**TOWN OF HERNDON, VIRGINIA
HISTORIC DISTRICT REVIEW BOARD WORK SESSION AGENDA
NOVEMBER 3, 2021
HERNDON POLICE DEPARTMENT, COMMUNITY ROOM
397 HERNDON PARKWAY
7:00 P.M.**

2. **APPLICATION FOR BUILDING ADDITION, HDRB #21-013**, to consider an application for an one-story with basement, 2,410 square foot, rear addition to a single family detached residence located at 809 Monroe Street, Herndon, Virginia, approximately 200' north of the intersection of Monroe Street and Madison Street, and further identified as Fairfax County Tax Map 0104-02-0035. The property is zoned as R-10, Single Family Detach Residential, and consists of 19,533 square feet of land. Applicant/Owner: Shane Todd-Williams.

Case Number & Type: HPRB #20-013; residential addition
Case Summary: One story addition with basement and deck to the rear of noncontributing single family detached house
Case Location: 809 Monroe Street

Subject: Pre-application HDRB case, 771 Center Street, Herndon Virginia

Perspective views

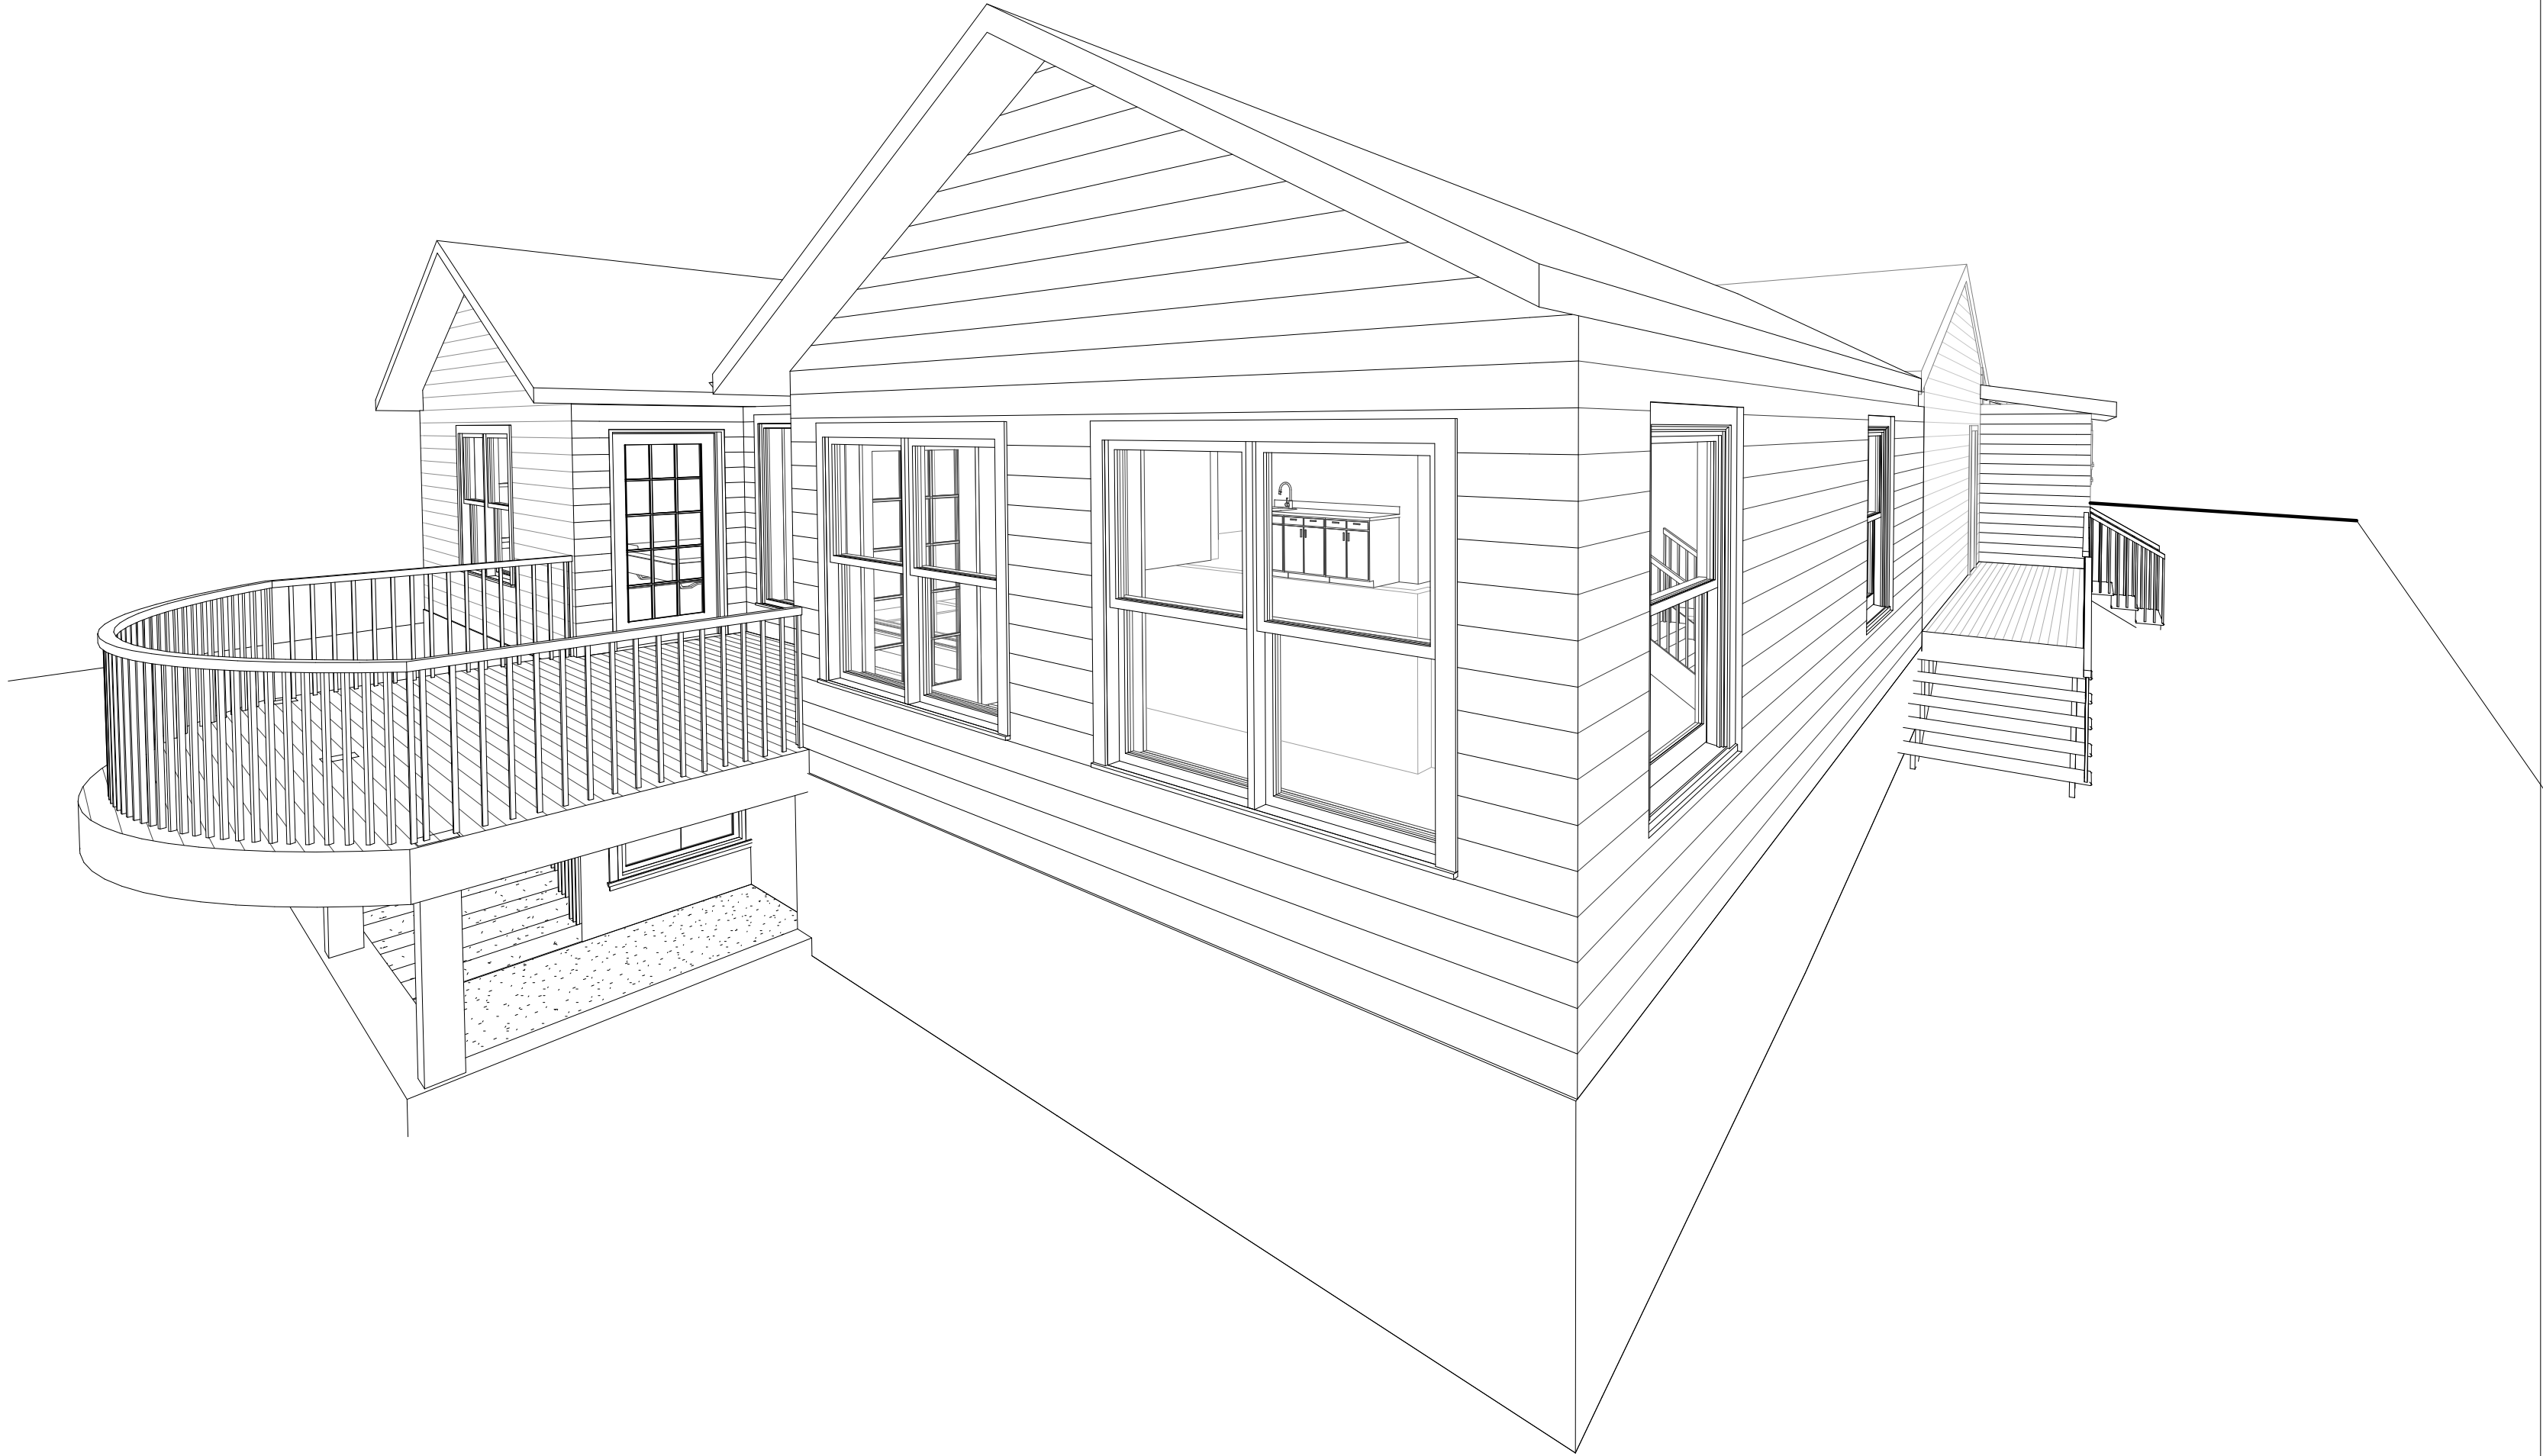
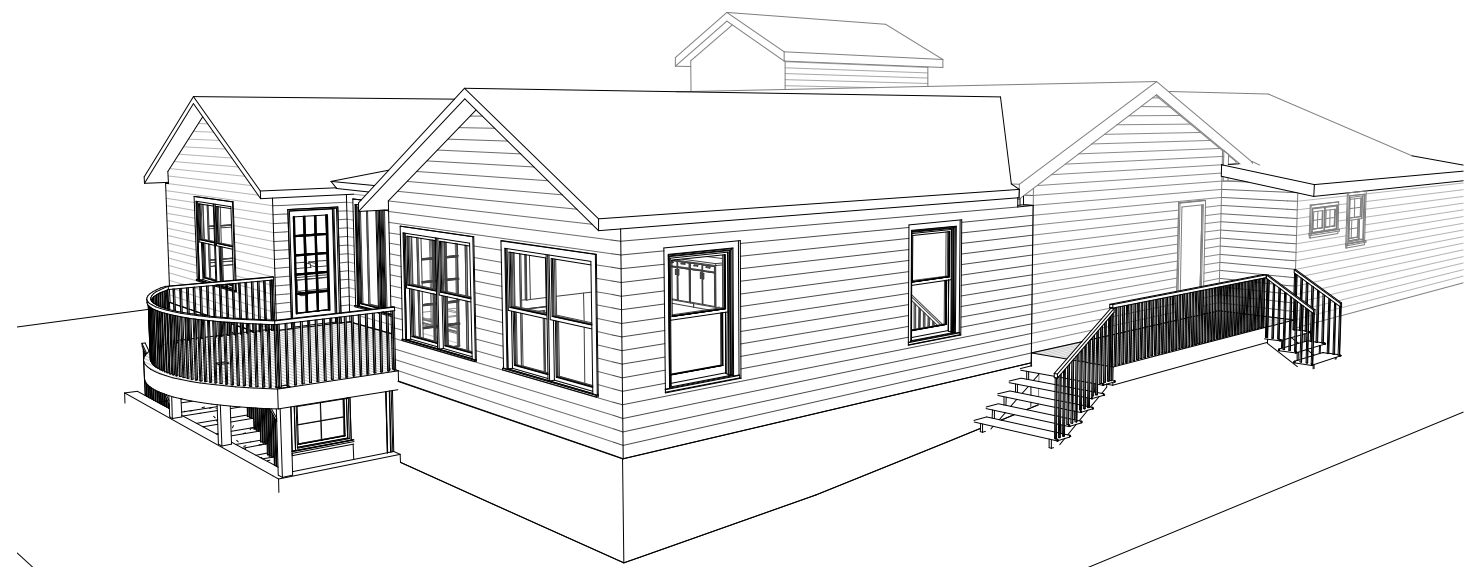
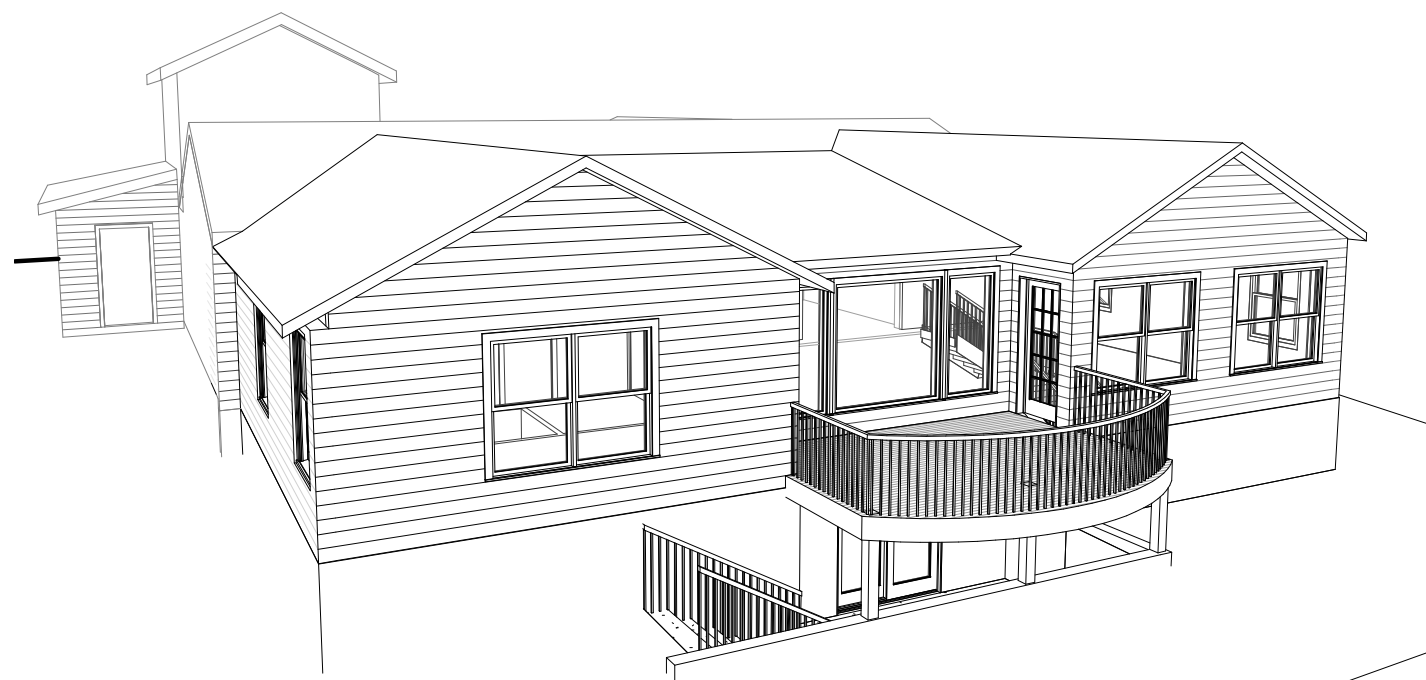
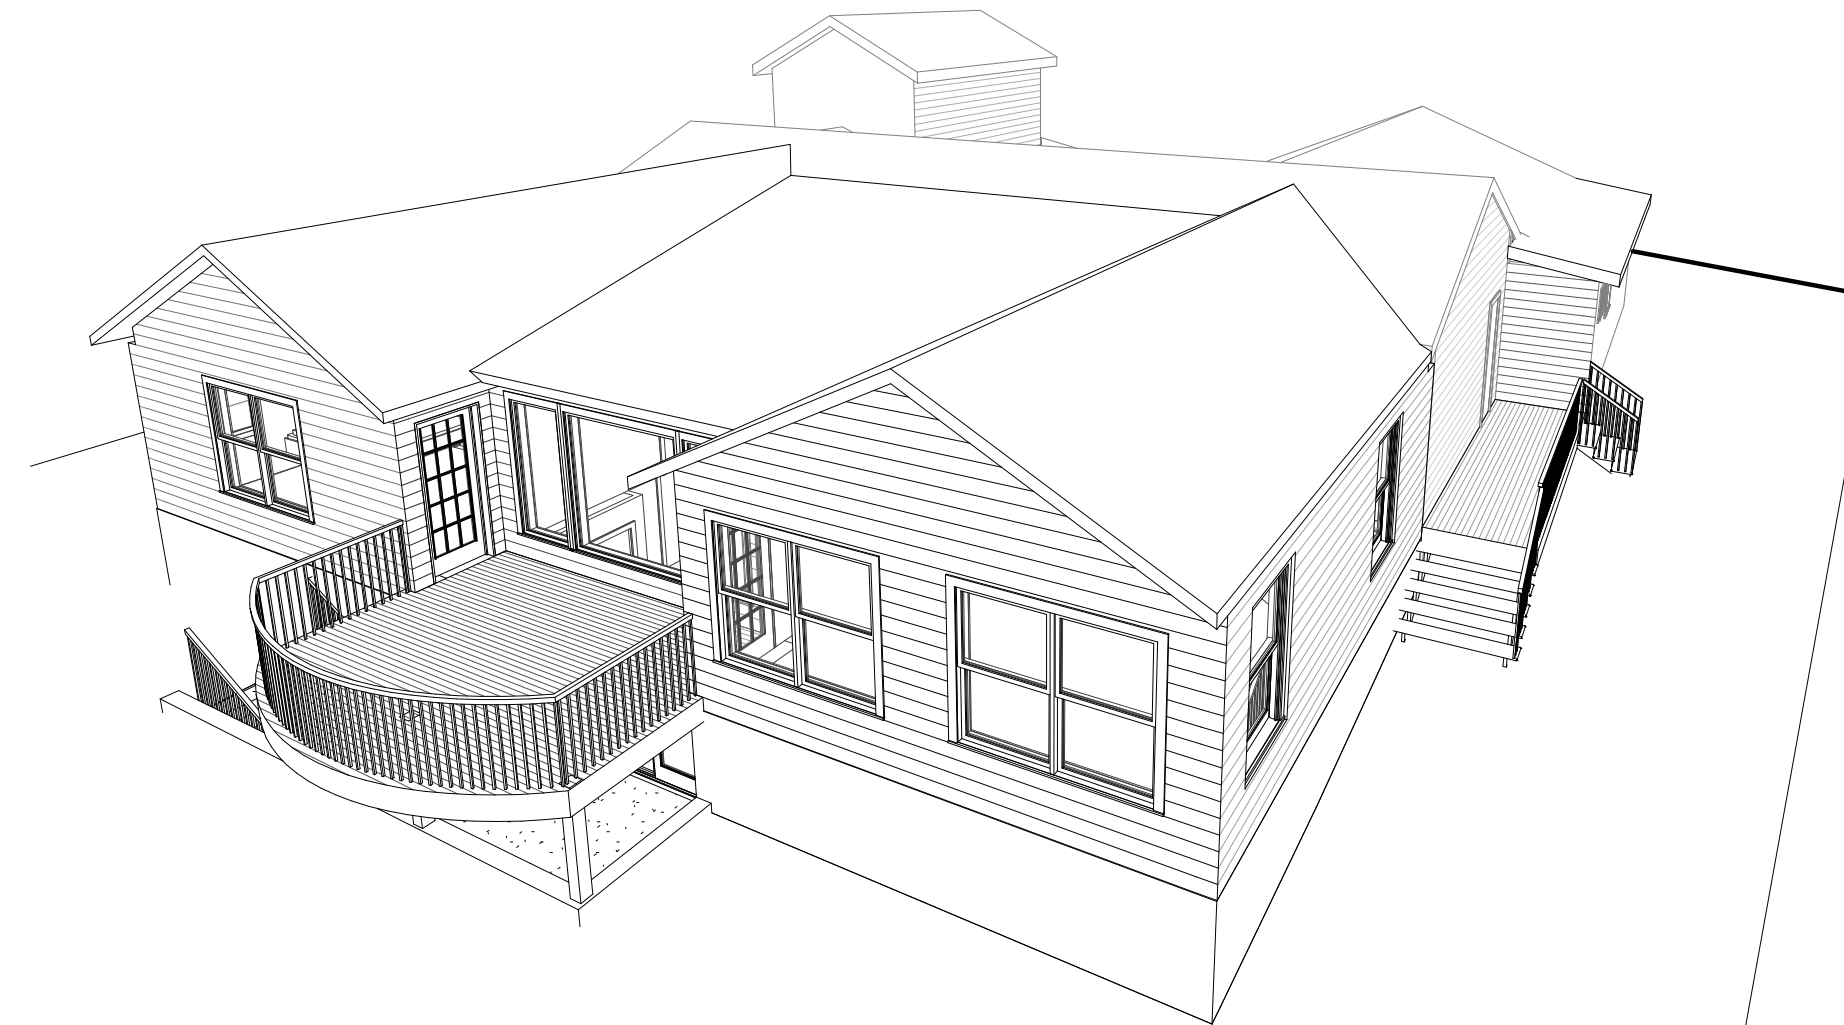
it is not an exact mirror, and the concept drawings indicate that the addition will be slightly narrower and shorter than the main part of the existing residence. This will help the addition to be understated and limit visibility from the right of way so that it has minimal impact on the surrounding area.

- Information regarding proposed exterior wall materials and finishes is limited at this point. Staff has requested additional details regarding this. It appears from the concept designs that the exterior siding will be a form of plank siding, which references portions of the existing front façade, but there is no indication about the material or color in relation to the existing structure.

2. There are a variety of windows portrayed in the concept designs with the most prevalent being undivided, 1-over-1 windows, normally in groups of two. way. No material, color, or functionality details are provided. The existing structure has a variety of window styles as well, though most are divided by muntins. It is unlikely that any of the windows of the new addition will be visible from the right of way.

3. No information is provided regarding doors, their style, material, functionality, or location though presumably there would be a door at the basement level and at the deck level. More information is needed in this area to make a proper assessment of character and design and appropriateness.
